■INTERIOR

1. Front Console Box

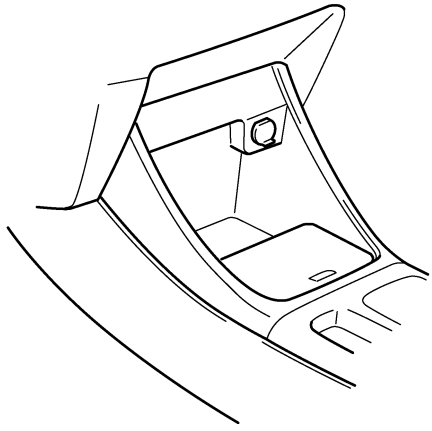
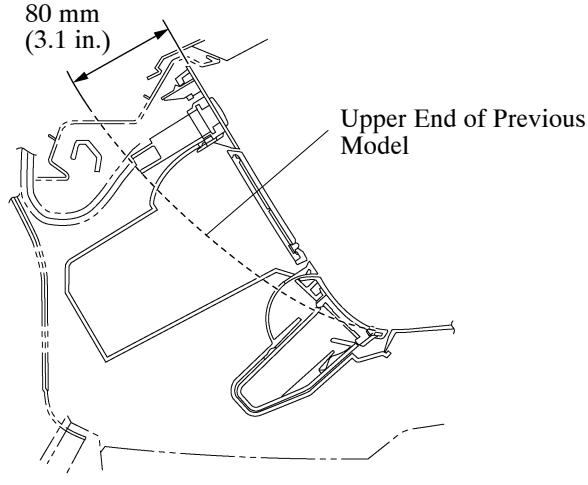
- The front console box has been changed to a type with a push-open door, thus achieving a luxurious design.
- The upper end of the console has been raised 80 mm (3.1 in.) from the previous model, thus increasing the storage capacity.
